WINSOME FILING NO. 3
EL PASO COUNTY, COLORADO
CONSTRUCTION DOCUMENTS
HORIZONTAL CONTROL

WINSOME FILING NO. 3
EL PASO COUNTY, COLORADO
CONSTRUCTION DOCUMENTS
CULVERT 1-PLAN & PROFILE

Culvert CDs_v1 redlines.pdf Markup Summary

CULVERT CROSSING NO. 1
SCALE: 1"=10'

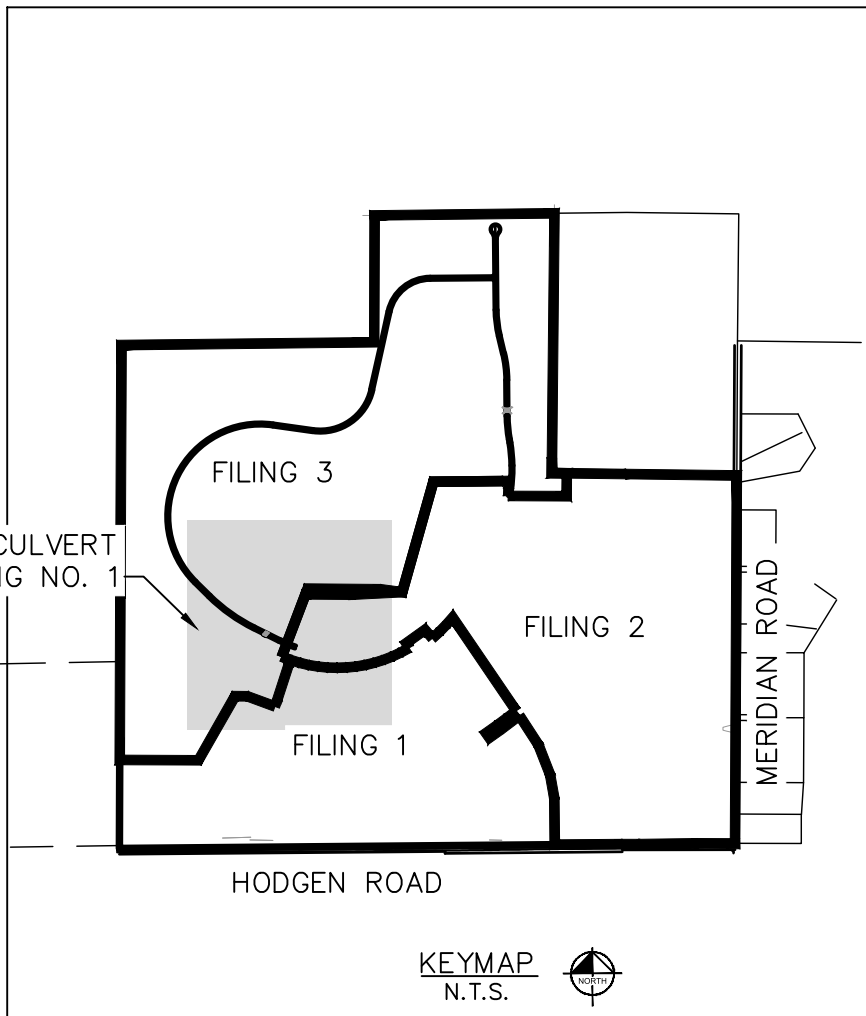
based on the contour it appears the wingwall needs to be extended. Update all wingwall lengths.

Check that this label is pointing to the correct data/line

Label ROW

Add sheet #

Show the 100yr WSEL

Hydraulics report has outlet protection listed as Type L riprap. Update so plan and report match

Hydraulic report shows 0.50% slope. Revise report or plan to match

Show the 100yr WSEL on the profile.

update the note. Is the 7322.50 the WSEL.

Maybe "Extend riprap to 7322.50 to provide 1 foot of freeboard"

Add reference to riprap detail on detail sheet

Label proposed and existing ground

Remove "extra" profile line

Label grade break

Show and label outlet protection and toewall

Show the riprap

Label profile horizontal and vertical scale.

Extend alignment past improvements

LABEL WAS ADJUSTED

ROW IS NOT LABELED

ADDED

RIPRAP WAS UPDATED TO TYPE L TO MATCH

THIS WAS UPDATED TO THE 0.5% SLOPE

100 YR WSEL IS NOW SHOWN ON THE PROFILE

REFERENCE TO THE RIPRAP DETAIL WAS ADDED.

LANGUAGE WAS UPDATED TO CLARIFY THAT THE RIPRAP WILL BE INSTALLED 1' ABOVE THE 100 WSEL

PROPOSED AND EXISTING GRADE ARE NOW LABELED.

EXTRA LINE WAS REMOVED

REVISED

Toe wall now shown along with outlet protection

Riprap now shown on the plan

ALIGNMENT WAS EXTENDED BEYOND RIPRAP

WINSOME FILING NO. 3
EL PASO COUNTY, COLORADO
CONSTRUCTION DOCUMENTS
ALAMAR WAY PROFILE

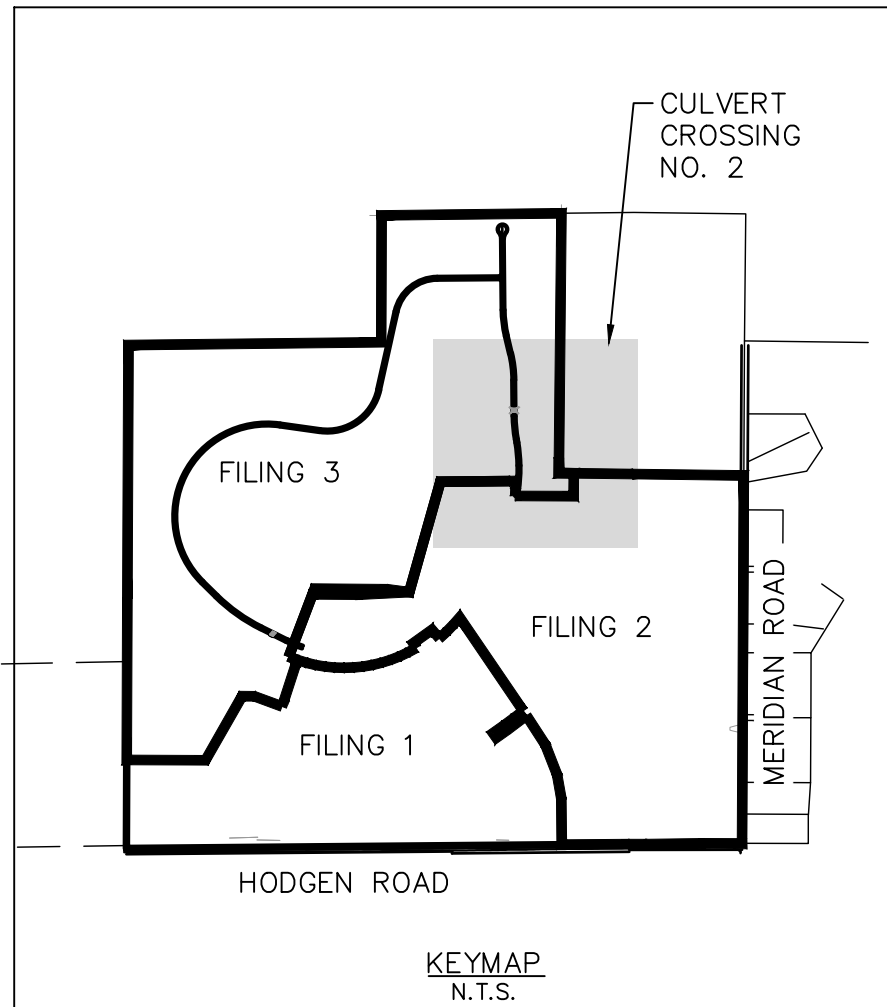
Label vertical scale

VERTICAL SCALE
NOW PROVIDED

WINGWALL (BOX CULVERT) SECTION DETAIL

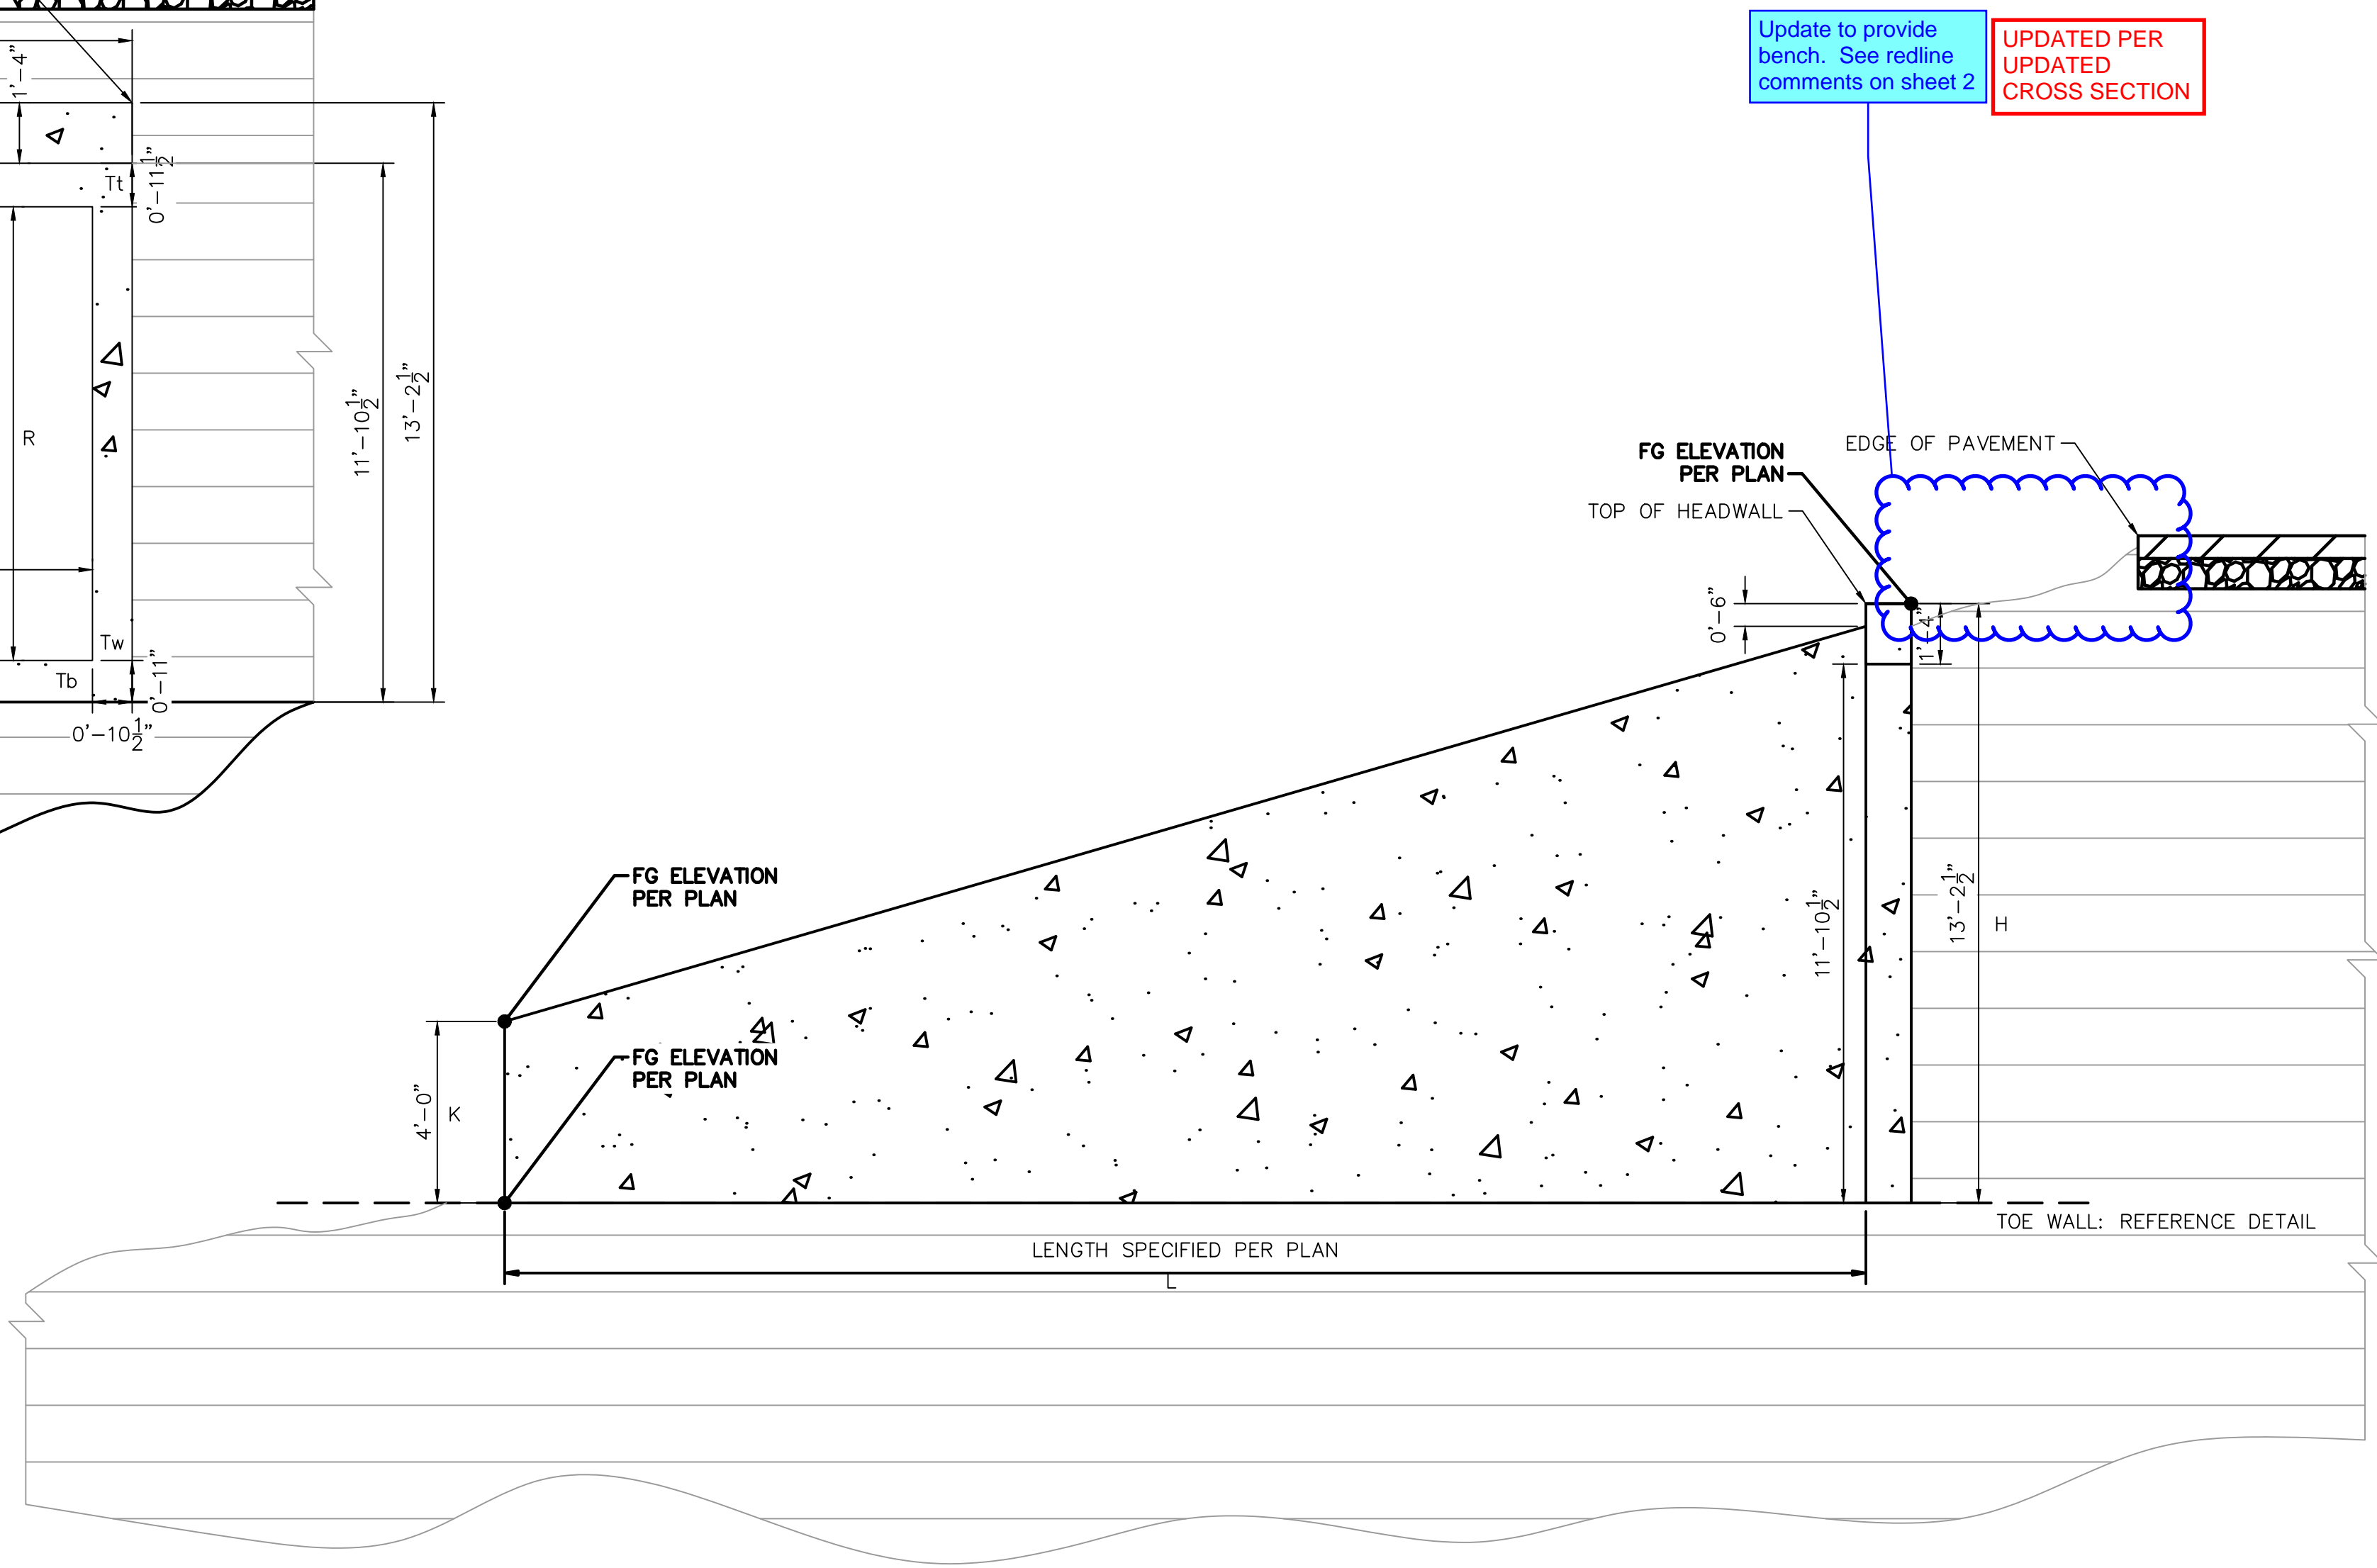
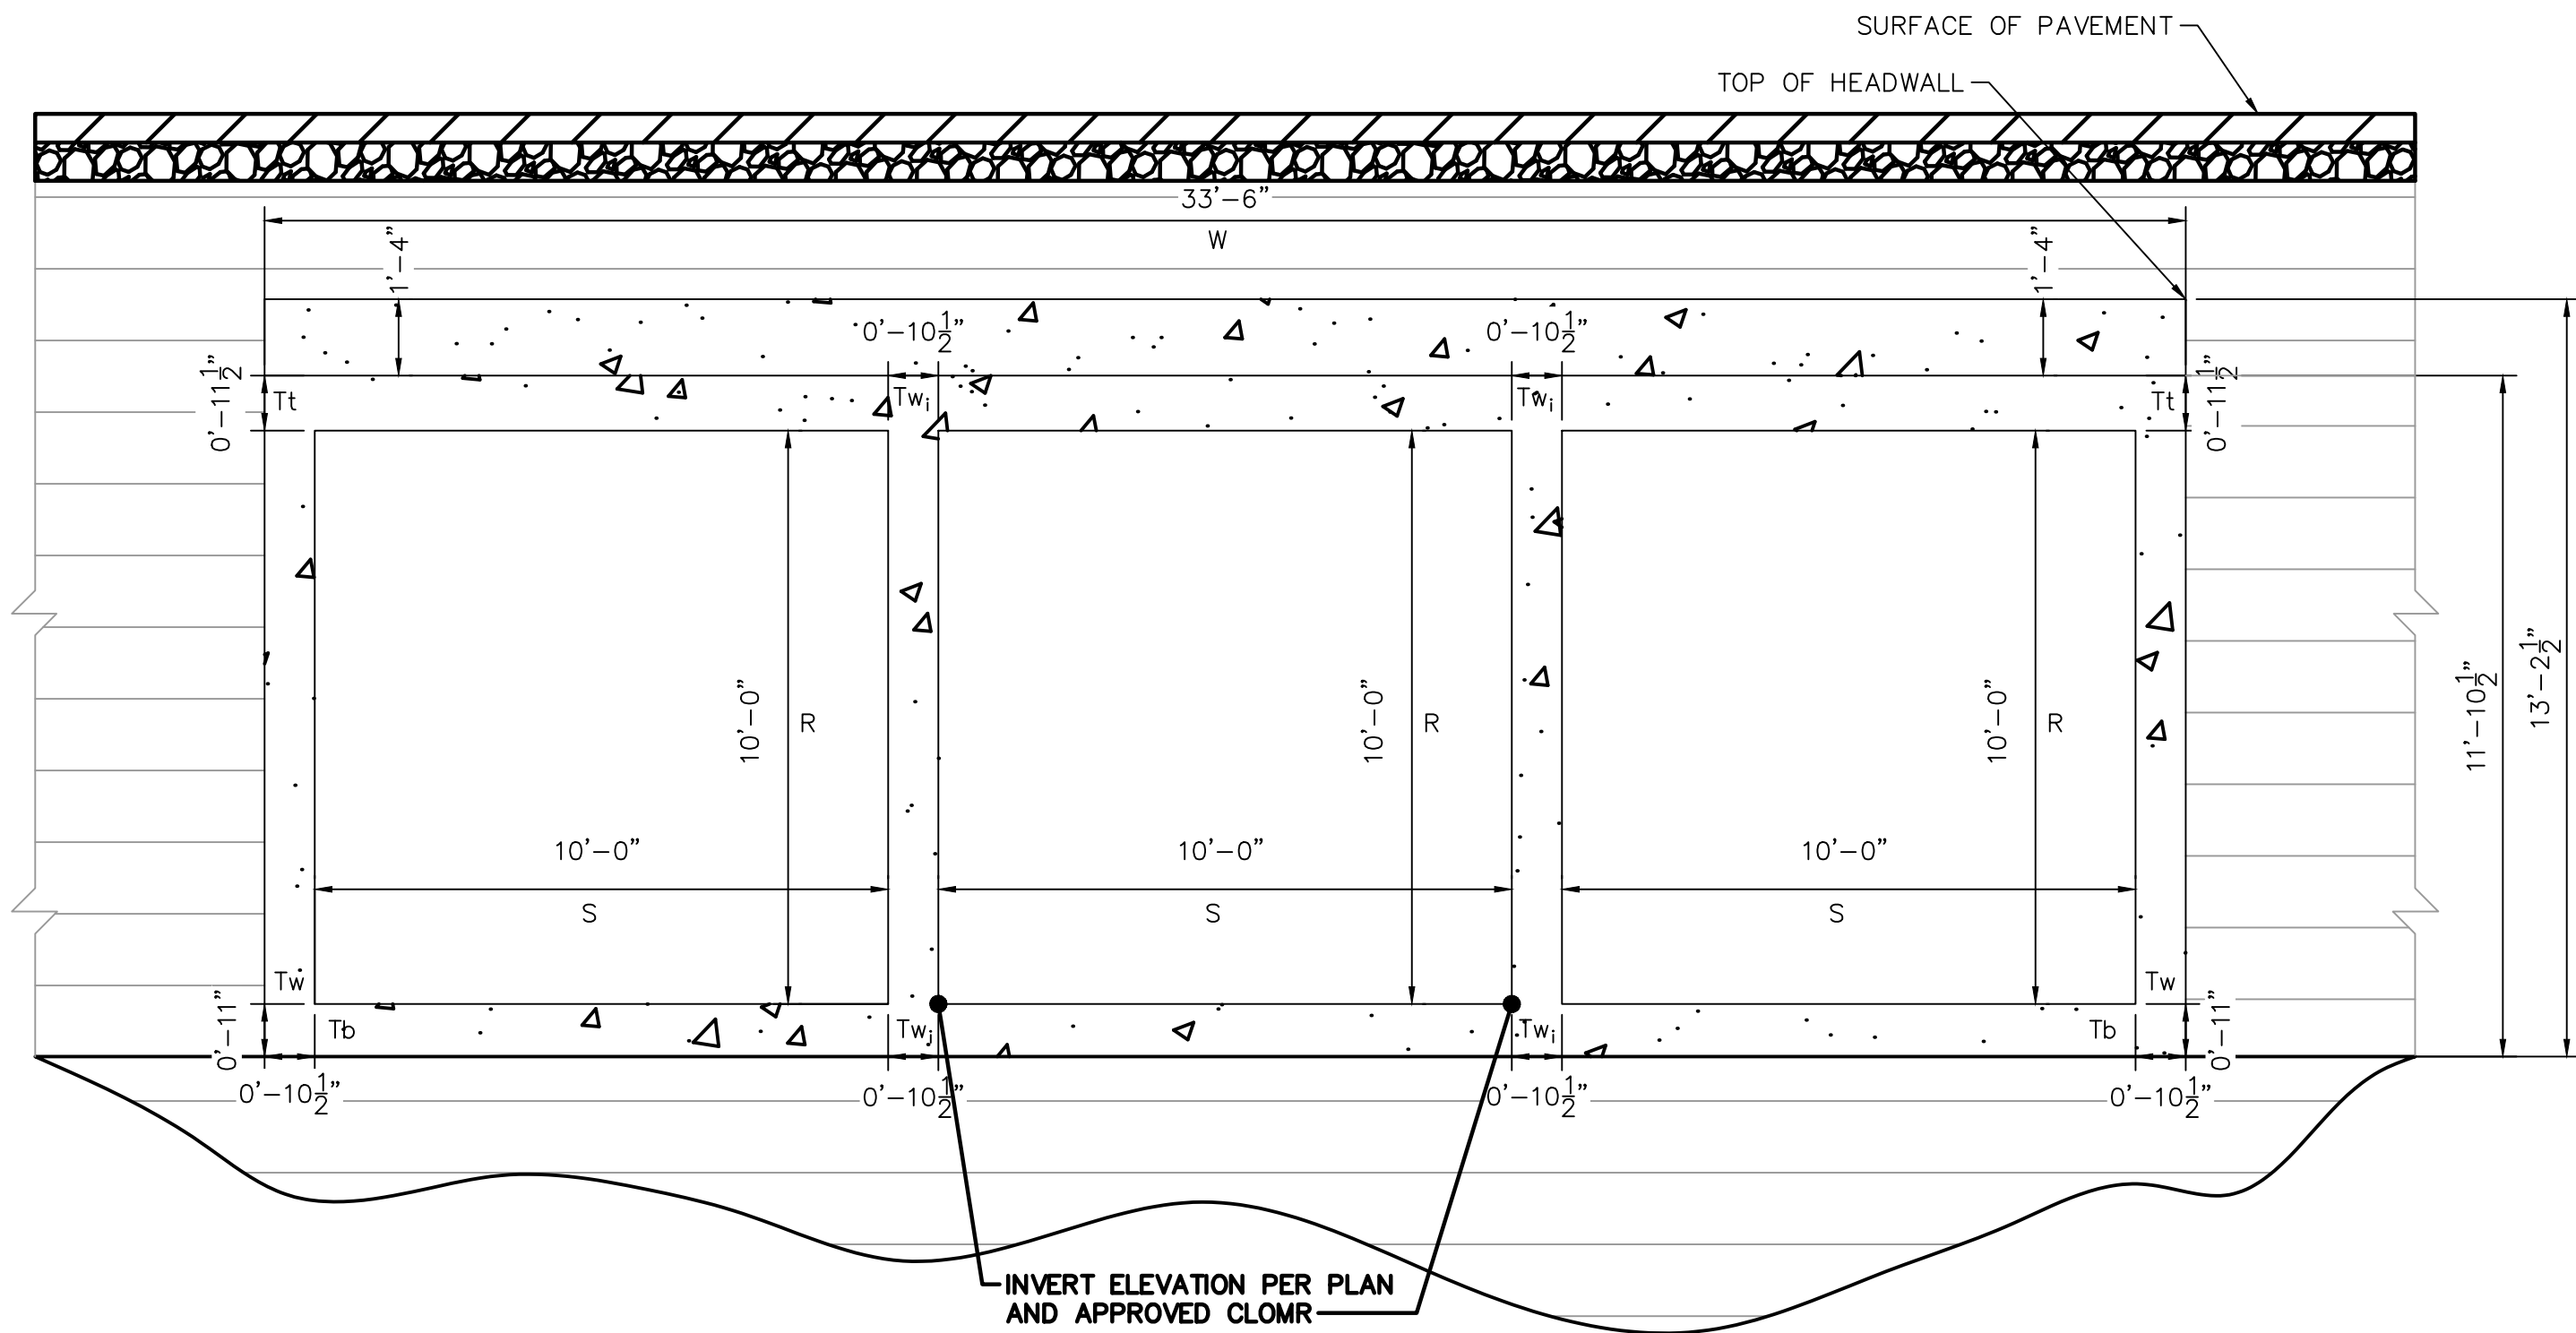
Update to provide bench. See redline comments on sheet 2

UPDATED PER
UPDATED
CROSS SECTION
